FHWA REGION NO.	STATE	PROJECT NO.	YEAR	SHEET NO.	TOTAL SHEETS
7	KANSAS	54-87 K-6657-01	2002	219	1122

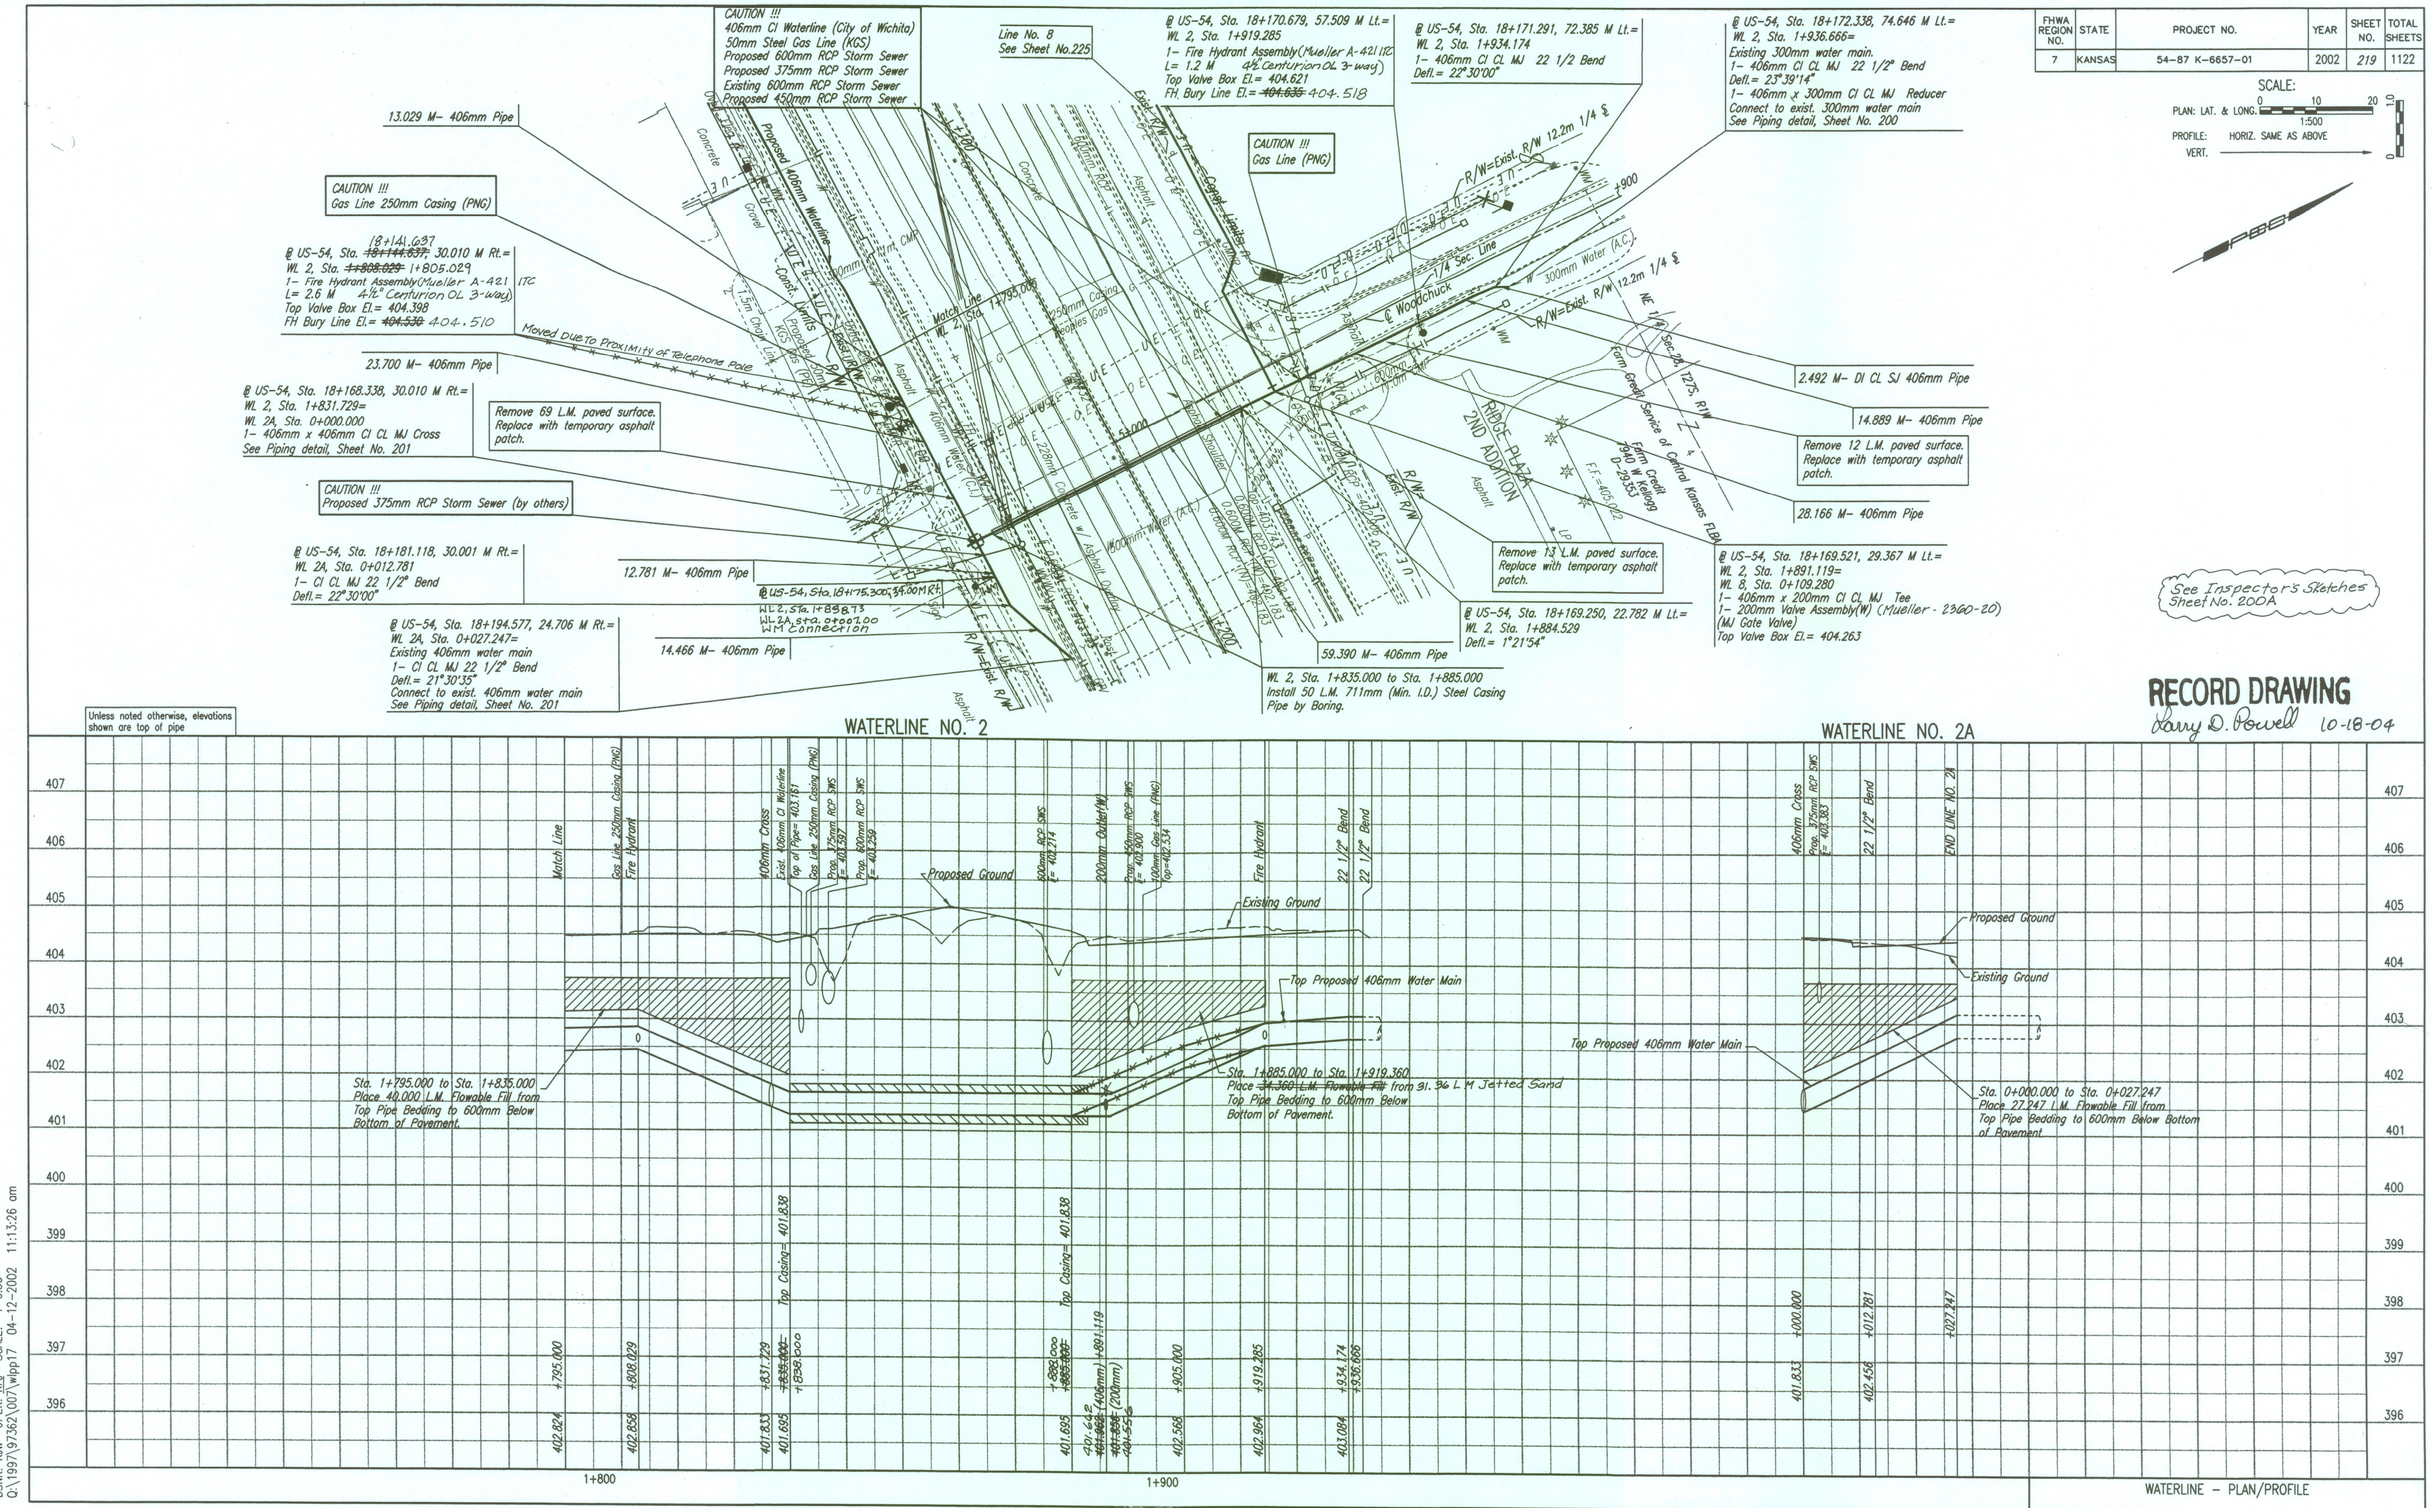
13.029 M- 406mm Pipe
CAUTION !!!
Gas Line 250mm Casing (PNG)
@ US-54, Sta. 18+141.697 ~~18+144.837~~ 30.010 M Rt.=
WL 2, Sta. ~~1+808.029~~ 1+805.029
1- Fire Hydrant Assembly(Mueller A-421 ITC
L= 2.6 M 4½° Centurion OL 3-way)
Top Valve Box El.= 404.398
FH Bury Line El.= ~~404.538~~ 404.510
Moved Due To Proximity of Telephone Pole
